Agenda
Lane Cove Local Planning Panel Meeting
22 October 2024

Lane Cove Local Planning Panel 22 October 2024
3 BROOKS STREET, LINLEY POINT

Subject: 3 Brooks Street, Linley Point
Record No: DA24/96-01 - 62447/24
Division: Planning and Sustainability Division
Author(s): Sam Wilson

Figure 2: Existing Basement Level (Source: Architectural plans drawn over by Council’s Planner)

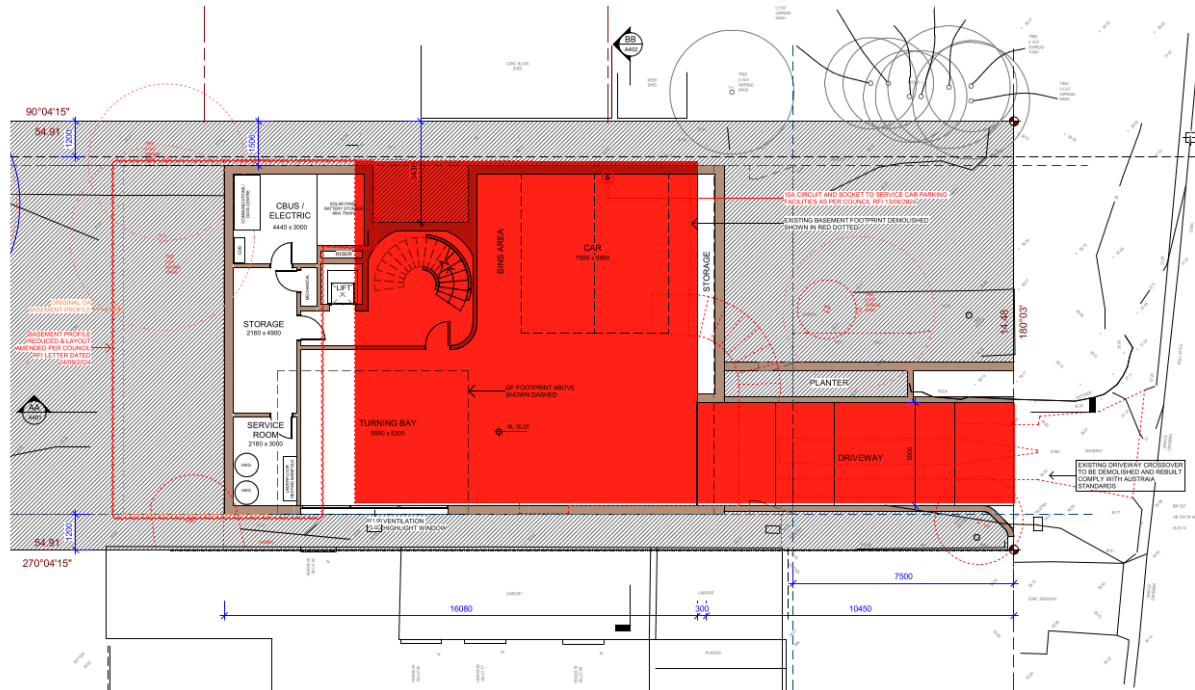
The development application proposes to demolish the existing structures on the subject site and develop a two-storey single residential dwelling with a 2-space basement garage, an in-ground swimming pool and a detached outbuilding. In order to accommodate for the basement garage, the proposal seeks approval for earthworks. The excavation shown in the architectural plans highlight that the earthworks would be undertaken from the Brooks Street boundary frontage westwards approximately 30.5m to the middle section of the site where the proposed basement footprint finishes. The maximum depth of excavation on the subject site reaches approximately 2.3m; 1.3m in exceedance of the maximum 1m provision established under Clause 1.6 of Councils DCP. The total area of excavated soil would be approximately 200m². As established later in the report, Council considers the total proposed area of excavation excessive. It is noted that the existing dwelling house entails a lower ground level which is technically considered as a basement level as highlighted by Figure 2 below;

As a result of the proposed excavation, the variation is assessed against Clause 6.1A of the LCLEP regarding earthworks.

Figure 3: Proposed Deletion of Basement Area (Source: Architectural Plans drawn over by Council's Planner)

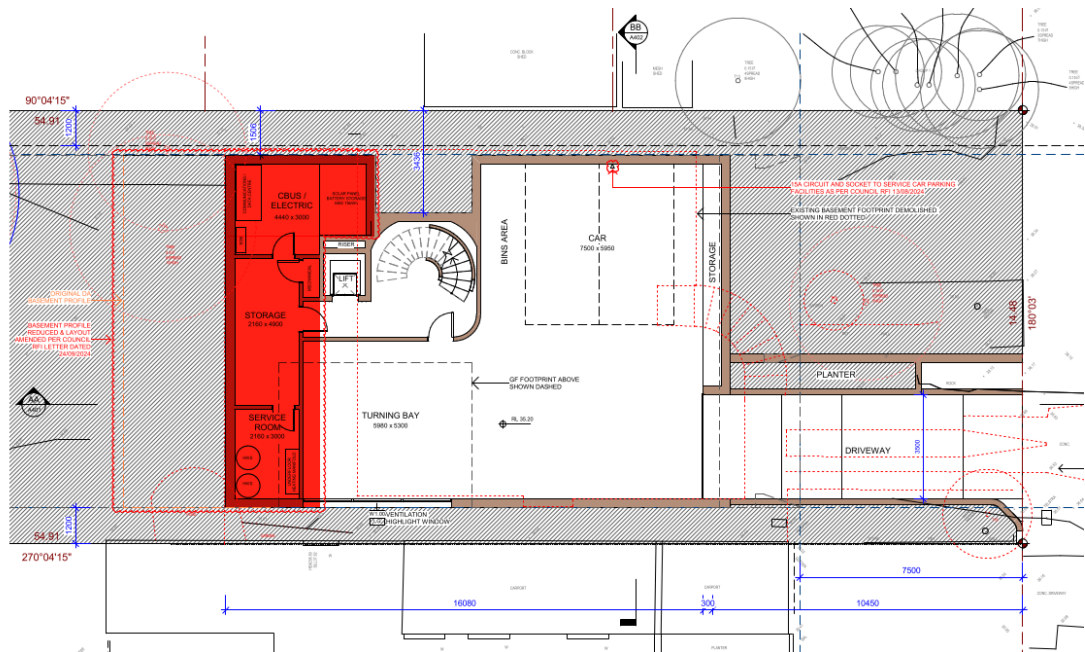
to the boundary. With the significance of excavation at the section highlighted below at a 1.2m distance from the boundary, there is the potential for undue impacts to the existing condition of this neighbouring property.

The addition of a 3 separate basement rooms titled as 'service room', 'storage room', and 'electric room', is considered excessive, and would result in an over excavation of an R2 Low Density Residential Site. This level of excavation is synonymous with residential flat buildings and other larger developments. In effort to limit potential structural and drainage impacts, Council recommends the deletion of the above highlighted area.

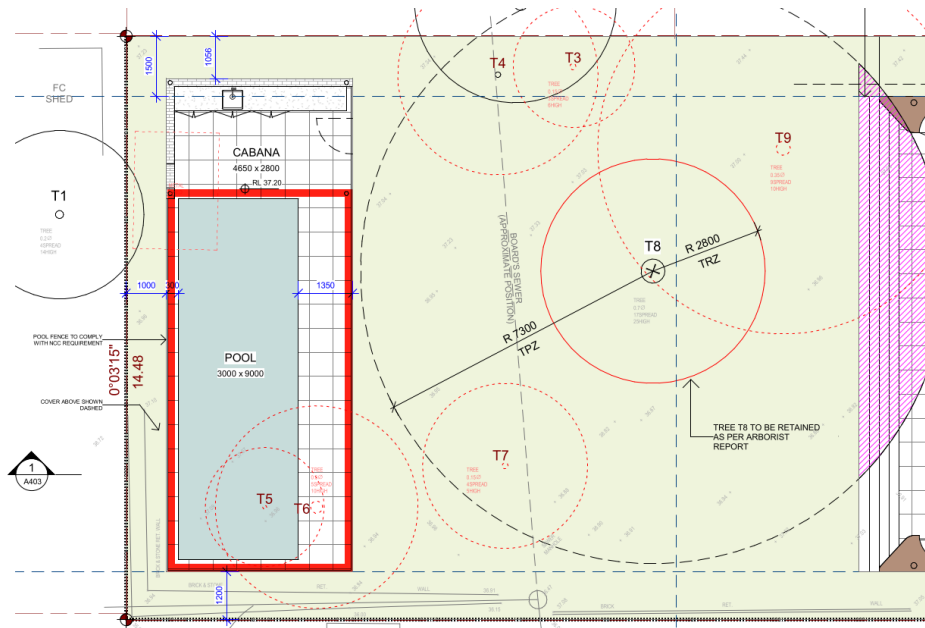
- a) **Reduction of Basement Area:** The areas specified as ‘storage’, ‘service room’, and ‘cbus/electric’ are to be removed from the basement floor plan. This area is highlighted in the figure below;

- b) **Amendment of Swimming Pool Fence:** The proposed swimming pool fence that surrounds the perimeter of the pool is to be free of any ancillary structures (cabana). In order to comply with the Australian Standards, the amended fence line is to follow the perimeter outlined in the below figure;

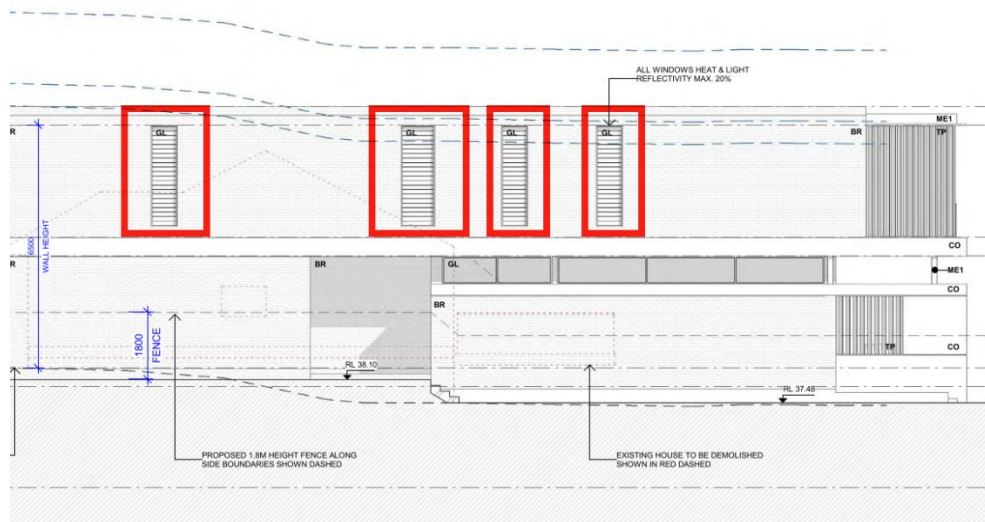
c) **Amendment of Windows:** The 4 north-facing windows located on the first floor of the proposed development are to be obscured by glazing. The windows are specified in the figure below;

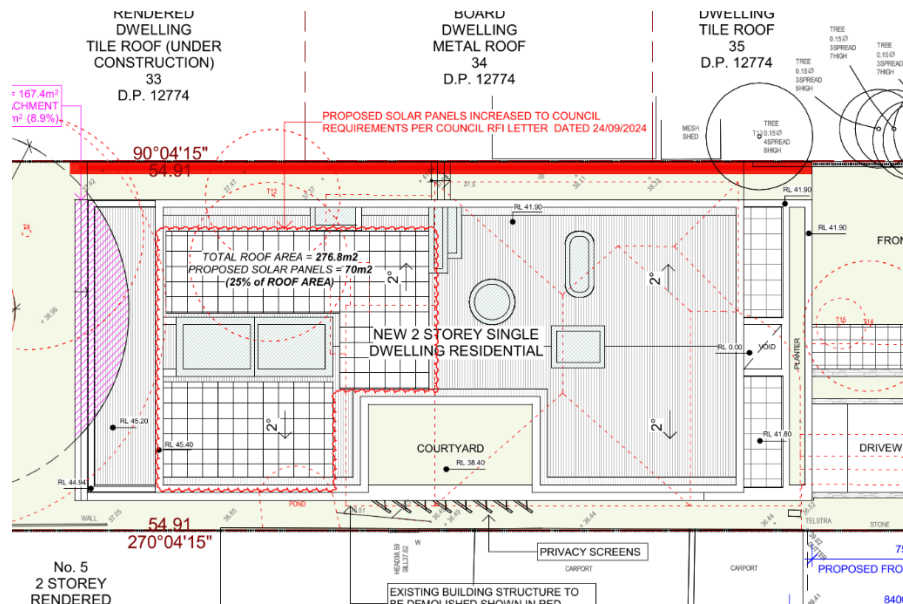
The area of vegetation is to span between front of the proposed dwelling to the rear. This is highlighted in red in the figure below;
